Document Number: WHC-SD-W236A-TI-004; Rev. 0

Document Title: Recommendation on Changing Interfaces of W-058 and W-236A

Recommended outcome of the reevaluation for implementing greater efficiency with Project W-236A (Multi-Function Waste Tank Facility) and Project W-058's (Cross Site Transfer Line) interfaces.

Figure 1. Recommended Changes for W-058 and W-236A Configuration

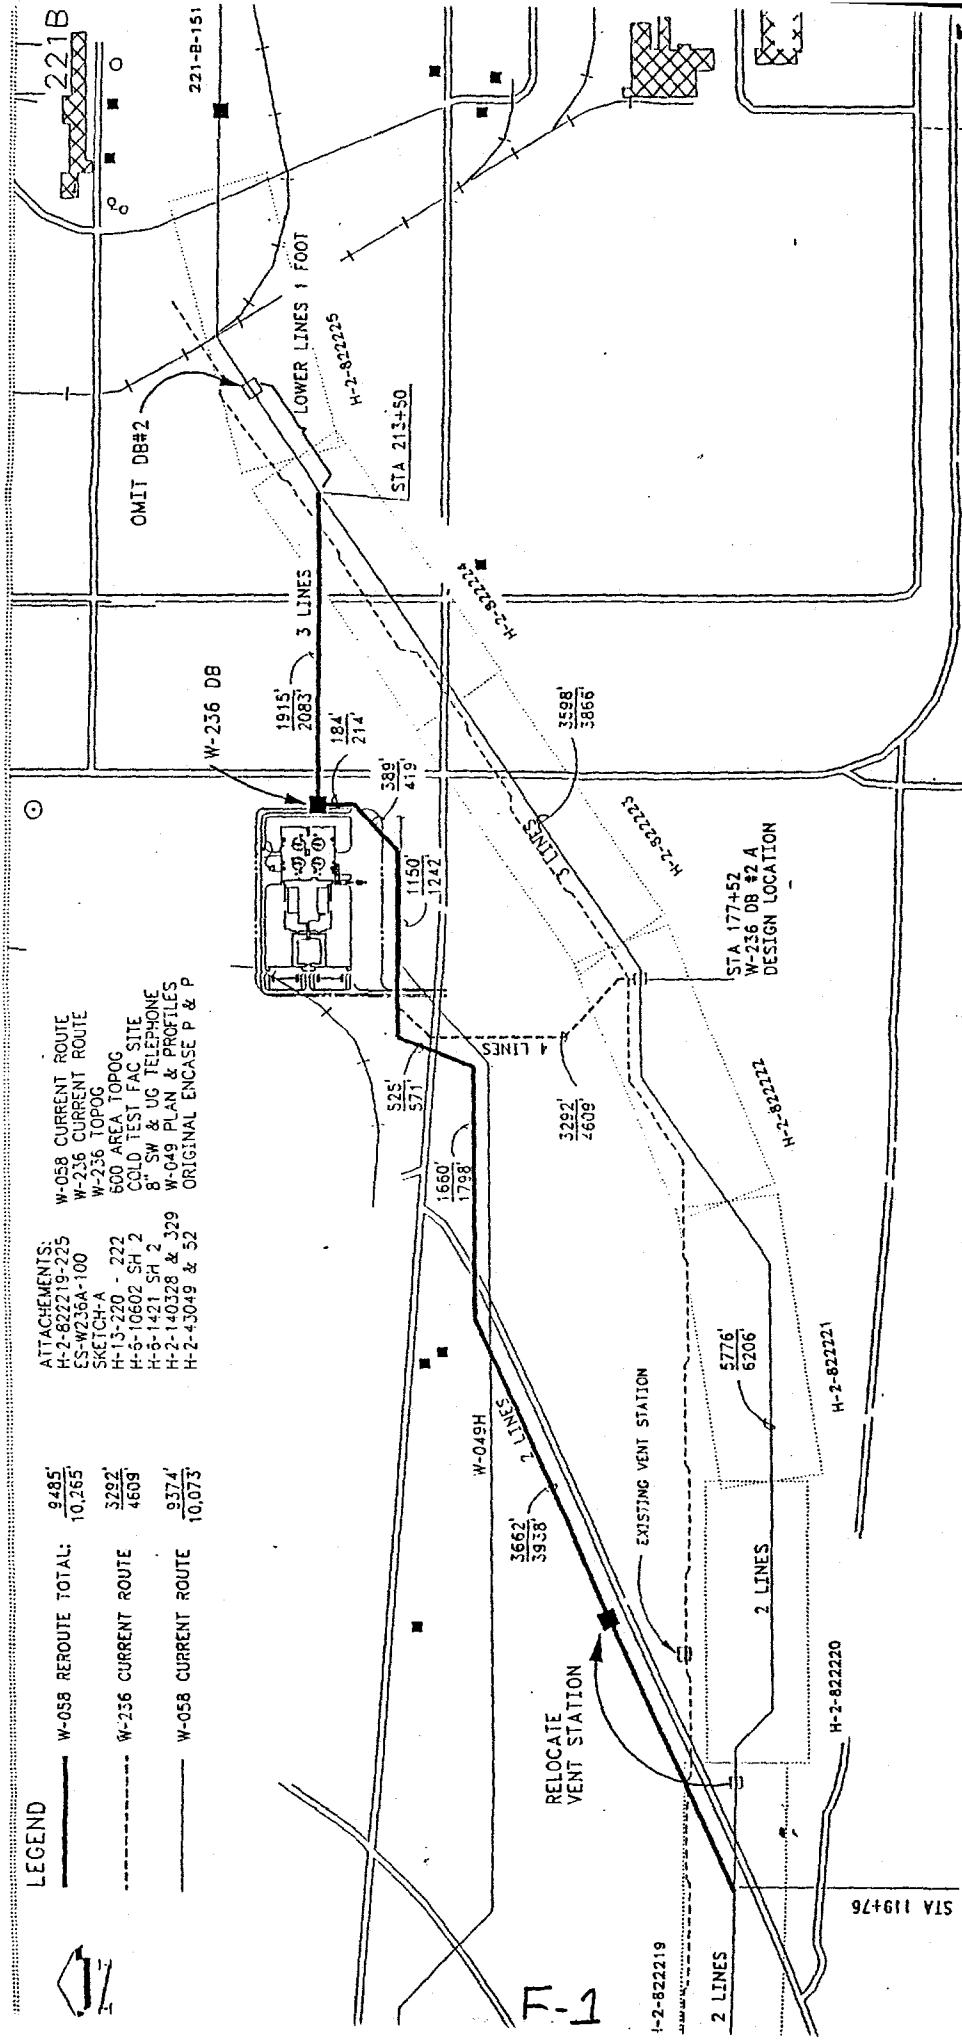
- Pumps are intertied for complete redundancy of pumping and piping systems. This includes the ability to pump waste from East Area tanks through 244-A and 151-AR to the west. (See Figure 1).

FIGURE 2
 Overview of Recommended Configuration
MWTF/W-028/W-058 CROSS SITE TRANSFER SYSTEM

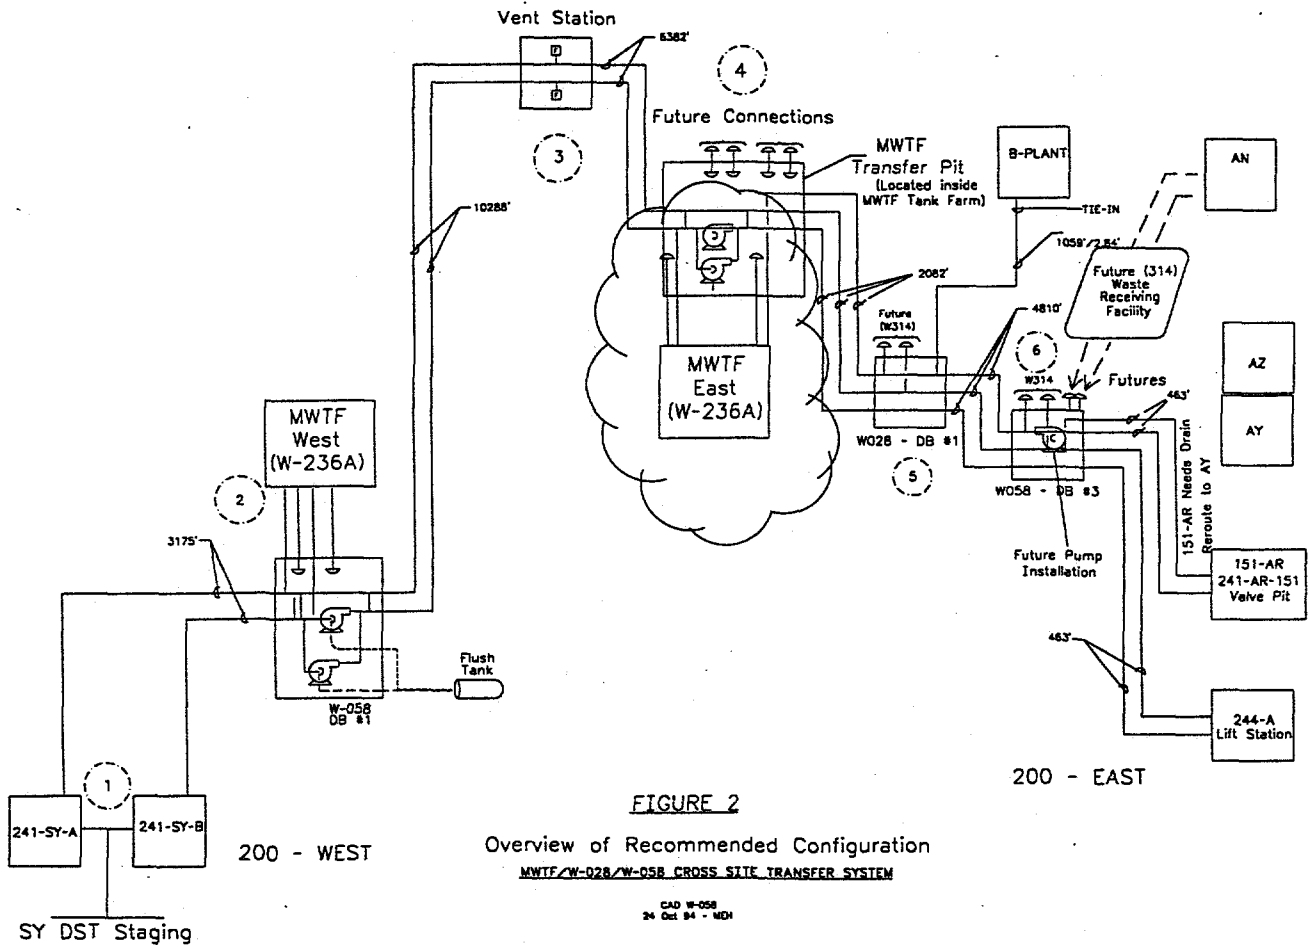
Figure 2 shows how the new tanks and the W-058/W-028 pipeline interface. One assumption with this figure is that the final processing will be located at the Site Alternative 1. However, Site Alternative 2 or 3 could be selected without affecting the recommendations in this paper. The overall plan for integrating these two projects is as follows:

3. W-058 vent station (vs) has pump deleted.
4. W-058 diversion box 2 and the W-236A transfer pit become one box with a booster pump and flush pump. W-236A East provides power, control location, and flush. As with diversion box 1, either pump can act as a transfer or a flush pump for either line. Either pump can be fed by a flush tank and powered by backup power. Pumps can provide backup flushing for a third line.

5. W-028 diversion box 1 has single-shell tank retrieval future connection points and B Plant tie in; three lines are retained to W-058 diversion box 3 from this point.

6. W-058 diversion box 3 has single-shell tank future connection points. Booster pump(s) are added at diversion box 3 for pumping to 200 East and 200 West. Pump is provided for 200 East to 200 West transfers within the East Area. In case of transfer failure, pump and piping can be flushed from diversion box 2 (now the W-236A transfer pit).

Figure 3

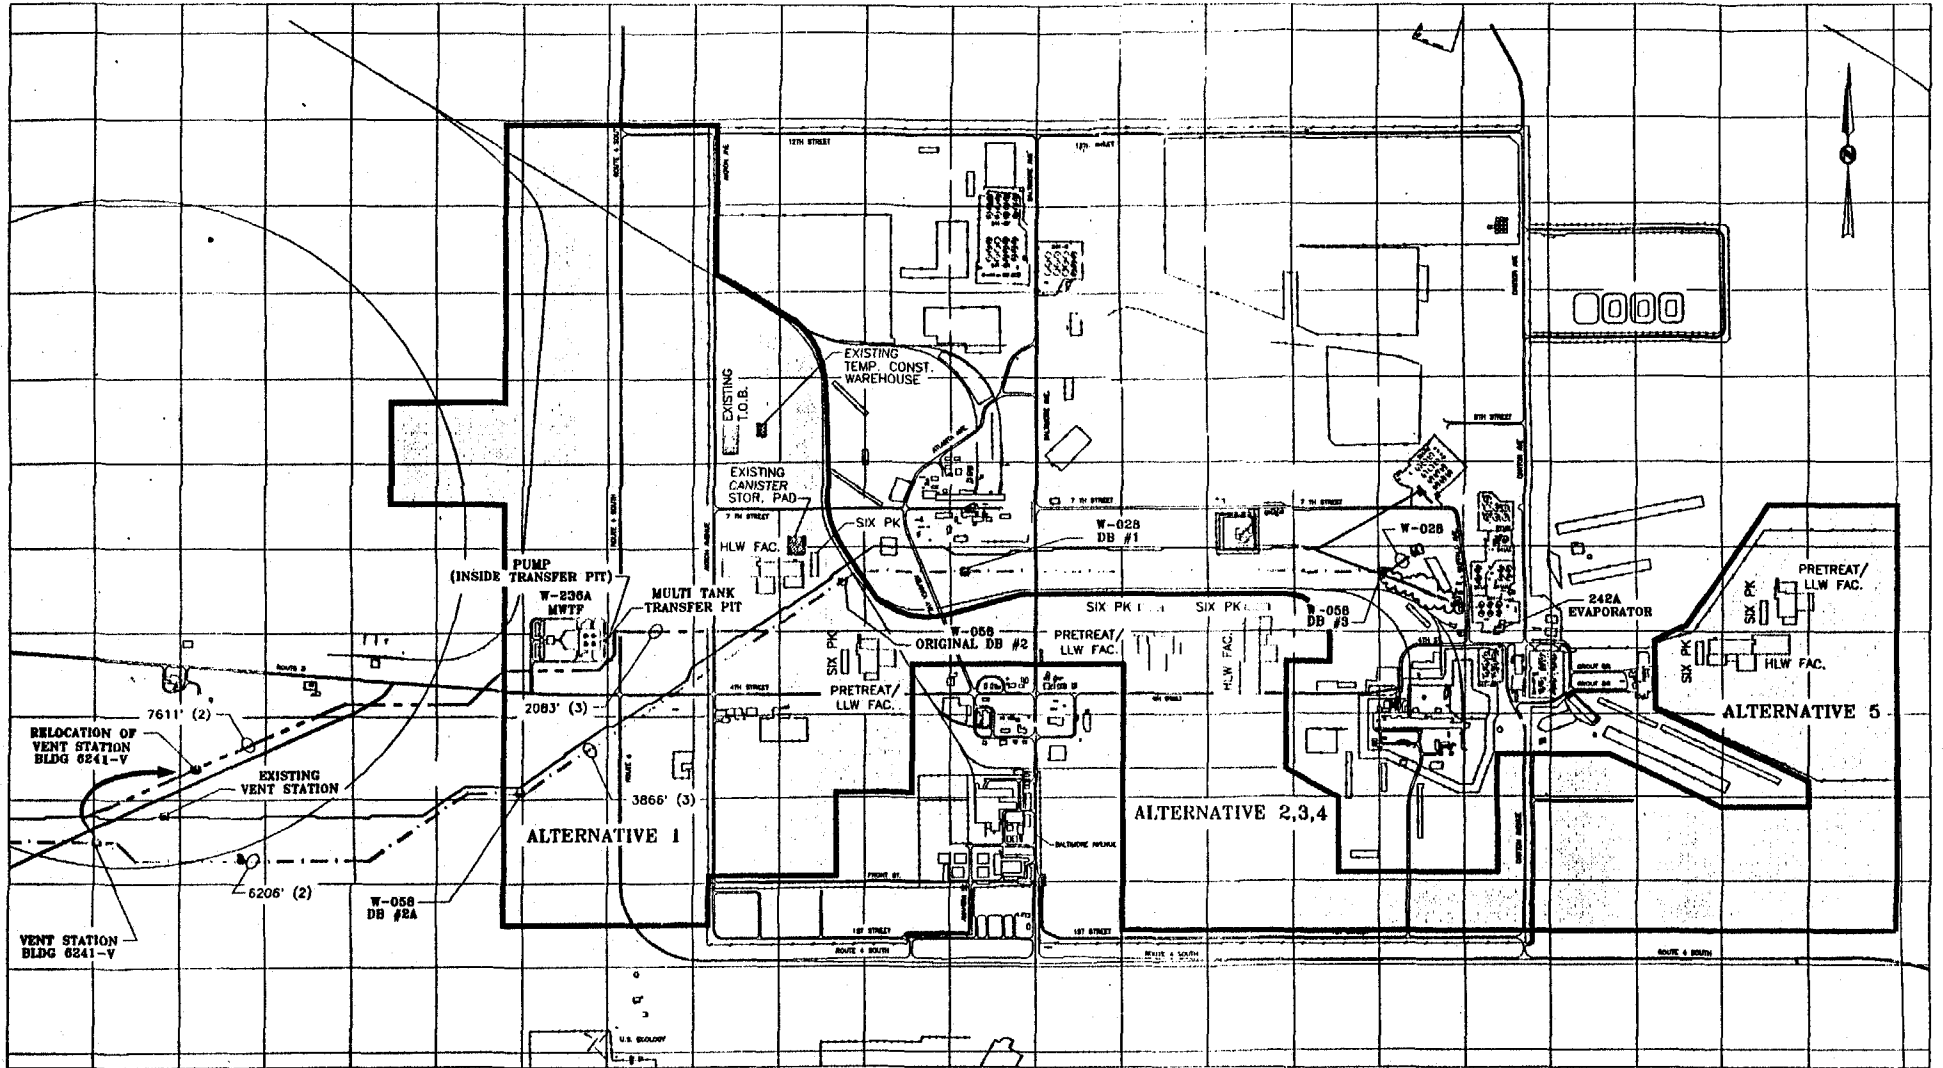
The recommended changes previously listed continue to support the three alternative candidate locations (as shown on Figure 3) for the high-level, low-level vitrification and pretreatment facilities. Depending on which site is the final location, the cross-site transfer system combined with the 200-East Area interfarm transfer system, will continue to provide the means to transfer waste to each location.
